## **Addendum No. 2**

Re: Part B - James M. Seals, JR. Park – Athletic Restroom/ Concession and Field Improvements  
504 Texas Street, Mobile, AL 36603  
**Project No. PR-041-20**  
Part C - Hackmeyer Park – Improvements Phase 2  
3810 Conway Drive South, Mobile, AL 36608  
**Project No. PR-034-21**

Date: November 22, 2022

AS1.1

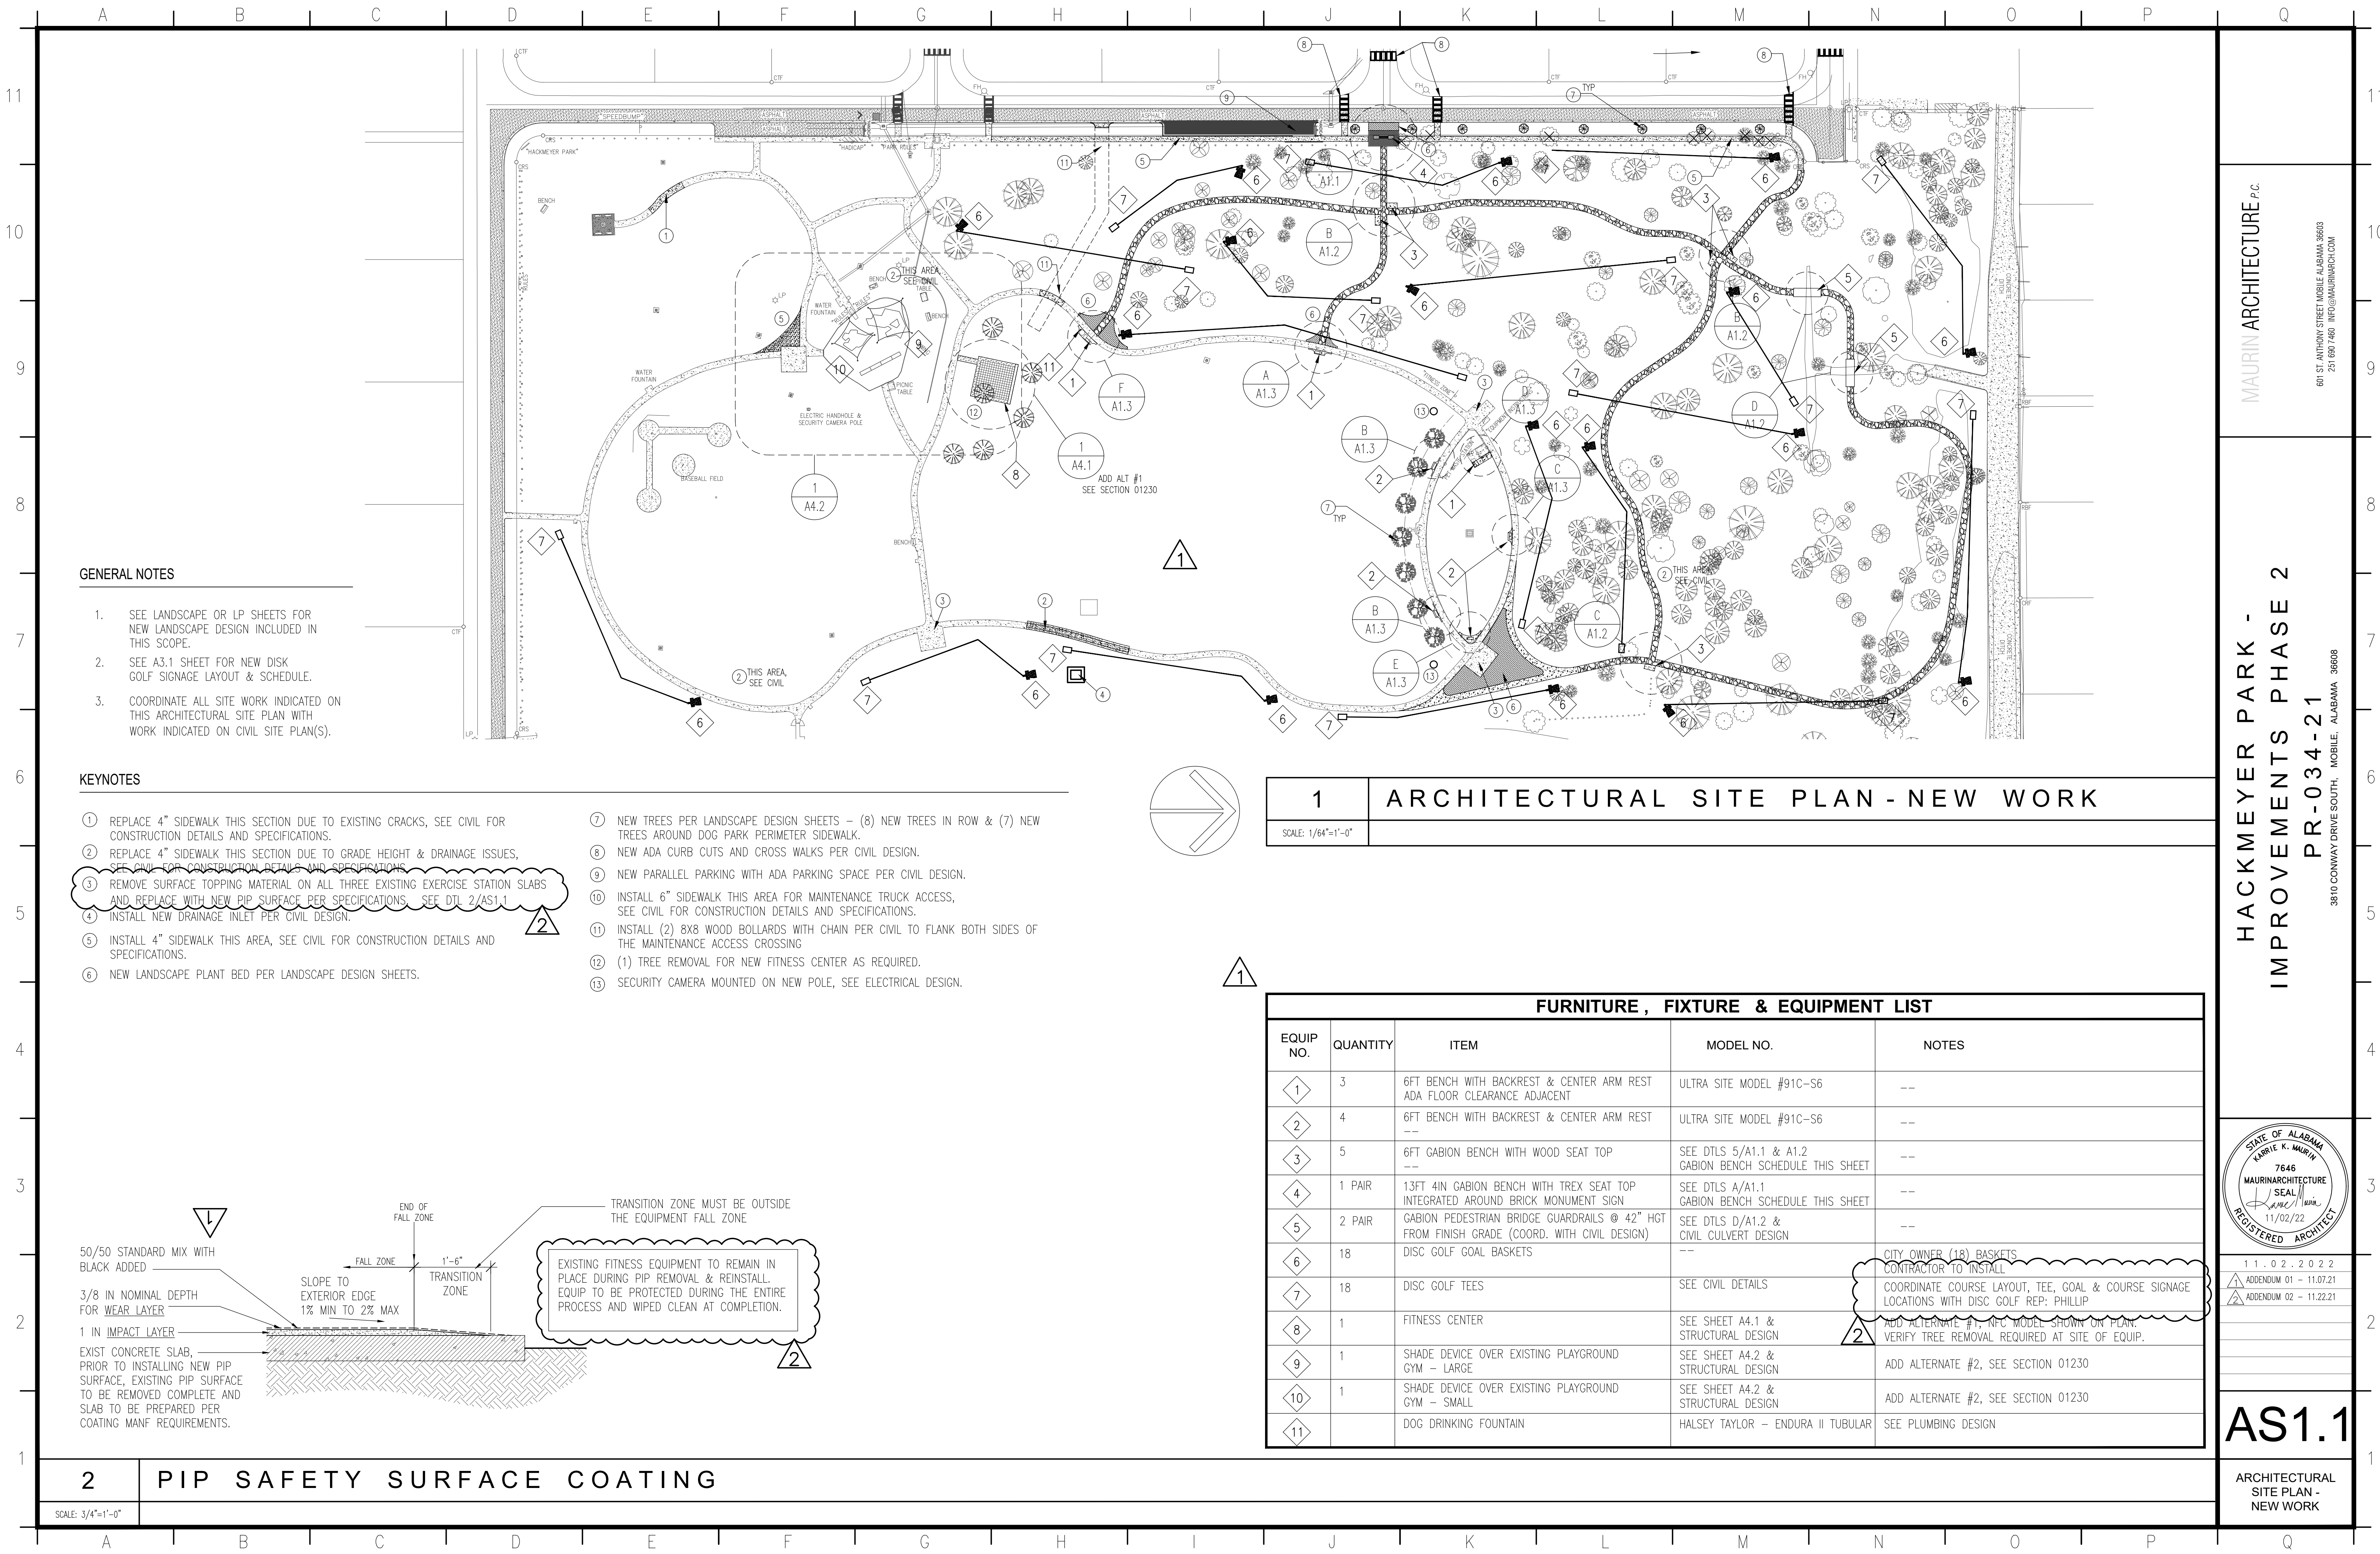
RFI 2: Required Fitness Equipment removal for PIP surface install.  
Drawing sheet AS1.1, detail 2/AS1.1

Question: Are we allowed to complete the job by pouring PIP around the fitness equipment instead of removing and reinstalling the equipment?

- Item 1: Sheet T1.1 Title Sheet  
Replace this sheet dated 11.07.22 and labeled Revision 01 (Addendum No. 1) with the attached revised sheet of same title T1.1, dated November 22, 2022 and labeled Revision 02 (Addendum No. 2). Substantial changes include the following:  
Update drawing sheet index.
- Item 2: Sheet AS1.1 Architectural Site Plan – New Work  
Replace this sheet dated November 07, 2022 and labeled Revision 01 (Addendum No. 1) with the attached revised sheet of same title AS1.1, dated November 22, 2022 and labeled Revision 02 (Addendum No. 2). Substantial changes include the following:  
Update Furniture, Fixture & Equipment List.  
Update keynotes on site plan.  
Update Detail 2/ AS1.1 notes regarding elimination of the requirement to remove fitness equipment for the install of PIP resurfacing.

**Response: The requirement to remove fitness equipment fixtures has been eliminated from the project scope.**
